**PLANNING BOARD
TOWN OF EAST HAMPTON**

SITE PLAN/SPECIAL PERMIT EVALUATION

Home Sweet Home

Prepared by: Marco Wu, Planner *MW JAO*

Proposed Old Filed Map Study
MAP NO. 501
Montauk Villa Park
EH - 17

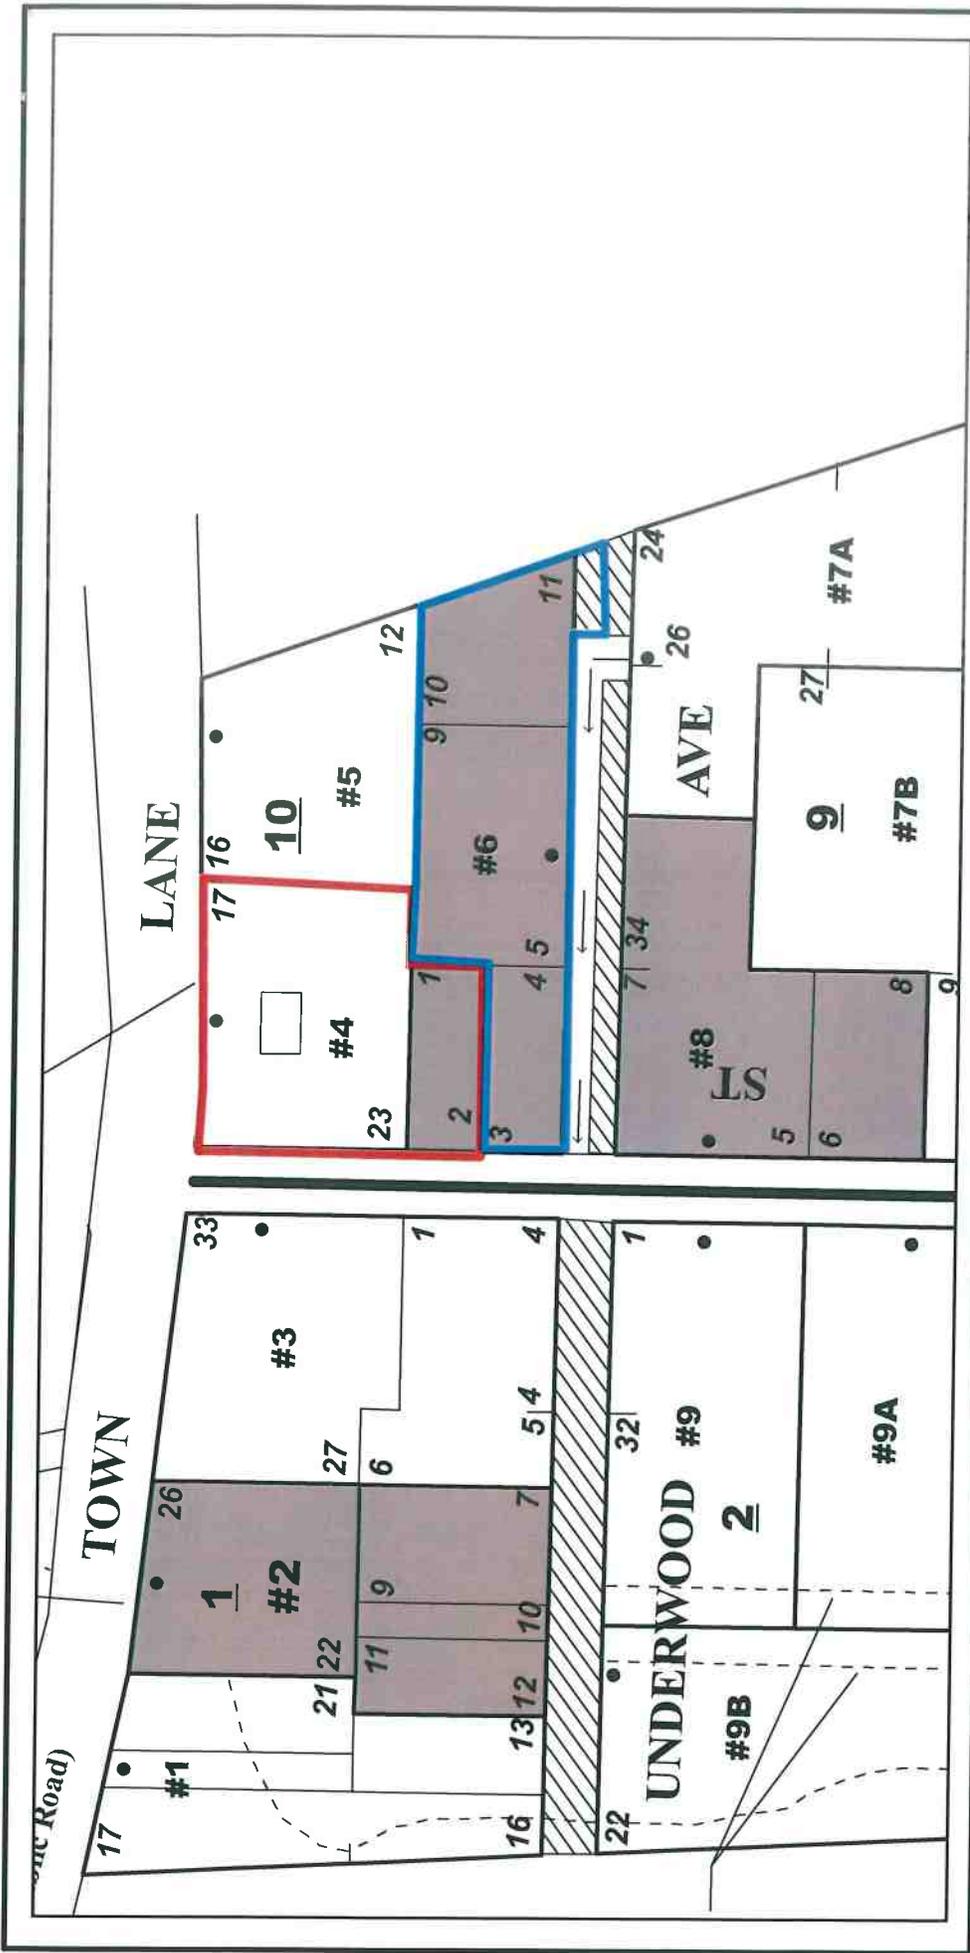
As a condition of the approval an Urban Renewal Modification is required. The applicants has submitted an application for this modification. The Planning Board should review the attached the Existing and Proposed UR Maps and form a consensus on whether or not to send comments to the Town Board of East Hampton who will ultimately need to approve the requested UR Map modification.

URP# 4, Lots 17-23
URP# 6, Lots 1-11

URP# 4, Lots 17-23 & 1-2
URP# 6, Lots 3-11

RESOLVED, the Planning Board recommends the Town Board approve this modification.

Existing Old Filed Map Study
MAP NO. 501
SCTM #300-167.000-0004-001.000
Montauk Villa Park
EH - 17

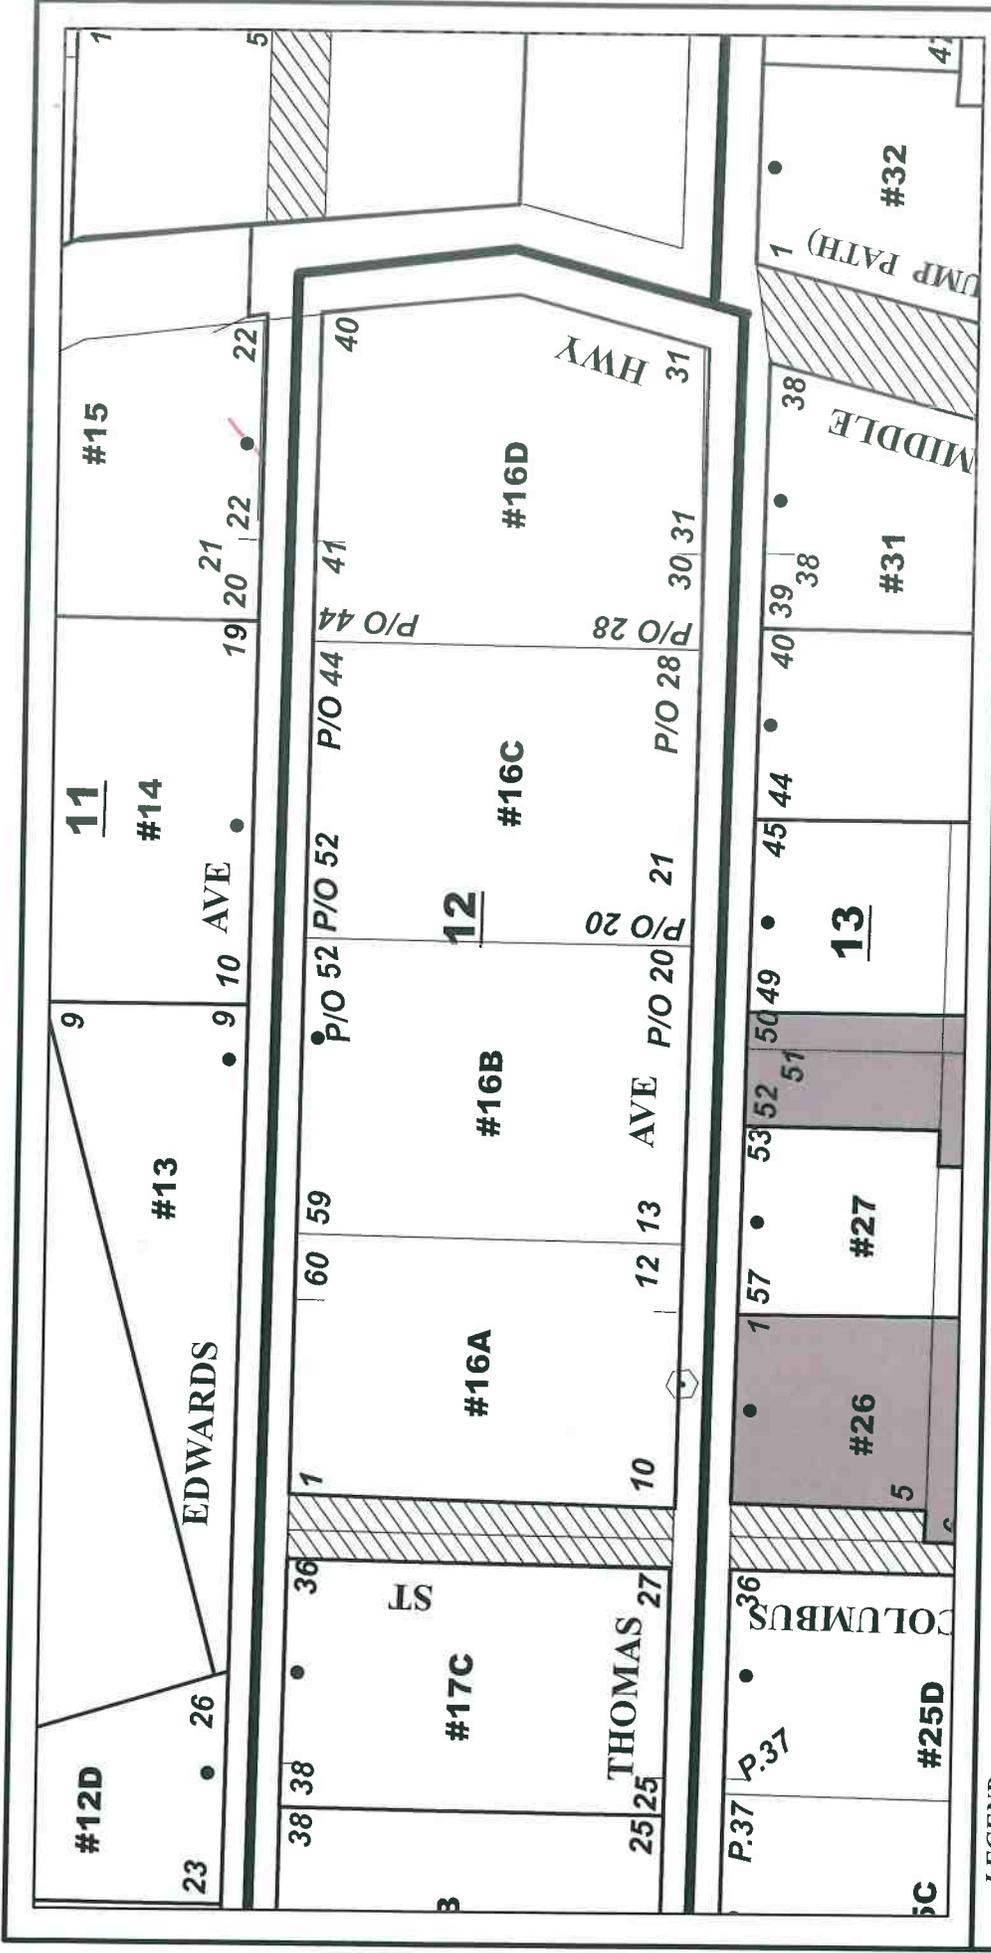
The only changes to this UR Map are that a cul-de-sac is being proposed at the end of Edwards Ave, from which Block #11, URP #15 and Block #12, URP #16D, the two easternmost properties will now take access from this cul-de-sac. In addition to that, the unopened road sections at the eastern end of Edwards Ave and the portion of Middle Highway between Edwards Ave and Thomas Ave will be designated as “to be abandoned” to match the approved Road and Drainage Plan. This portion of Middle Highway is not needed for access to any lot. The Board should discuss this abandonment of the part of Edwards Ave and Middle Highway to bring consistency with other plans and modify the map accordingly.

Change of access point to UR Map #501, Montauk Villa Park East Hampton, Block #12, URP #16D and Block #11, URP #15.

Edwards Ave is now a through street running from Royal Street to Middle Highway. The proposal is to terminate Edwards Ave in a cul-de-sac approximately 170' west of Middle Highway and to abandon this easterly portion of Edwards Ave. The proposal is also to abandon Middle Highway between Edwards Ave and Thomas Ave.

RESOLVED, the Planning Board recommends the Town Board approve this modification.
